SEMI Standards for EUVL Masks

Summary of July 23, 2002 SEMI EUV Mask Task Force

Summary of October 14, 2002 SEMI EUV Mask Task Force

Old Figure 1

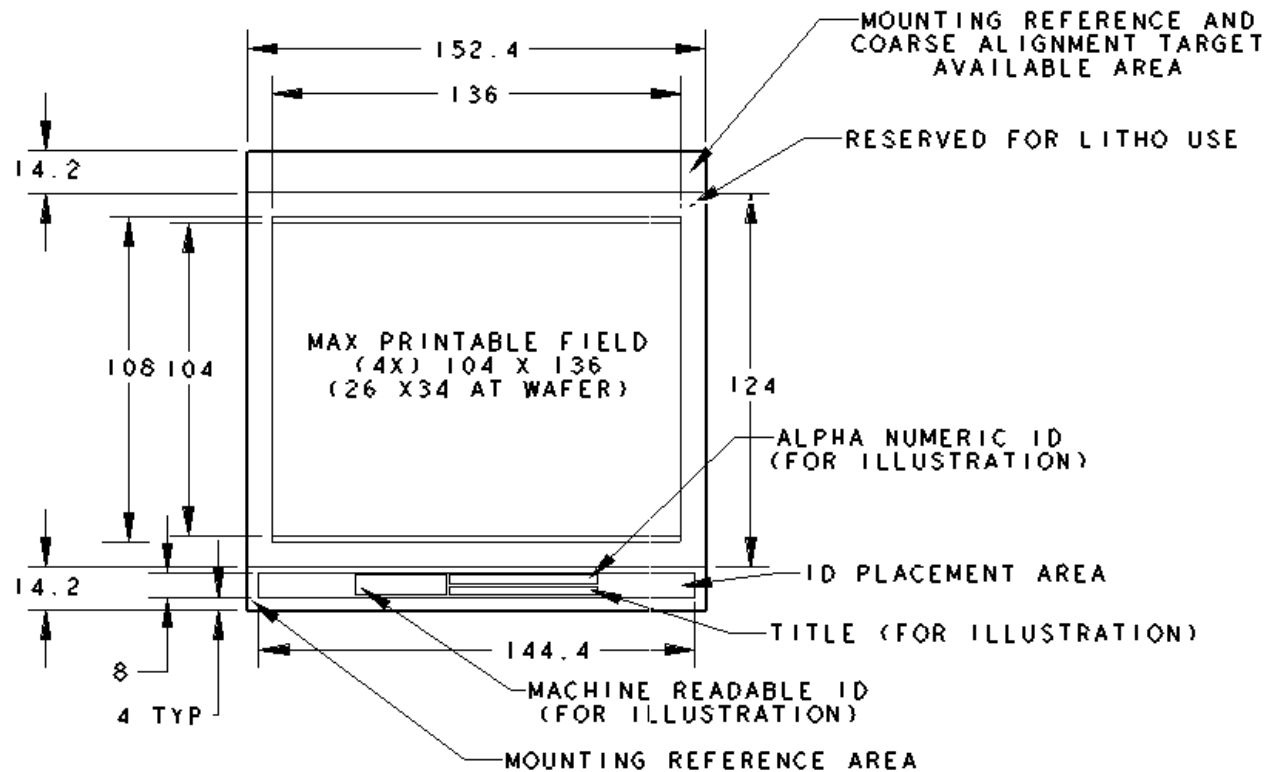
- **Replace Figure 1 with new ASML layout**

- Field size at wafer limited to 26 by 33 mm
- One of three versions supplied by ASML will be used for blue ballot (see ASML presentation)
- SEMI T11 data matrix could be included
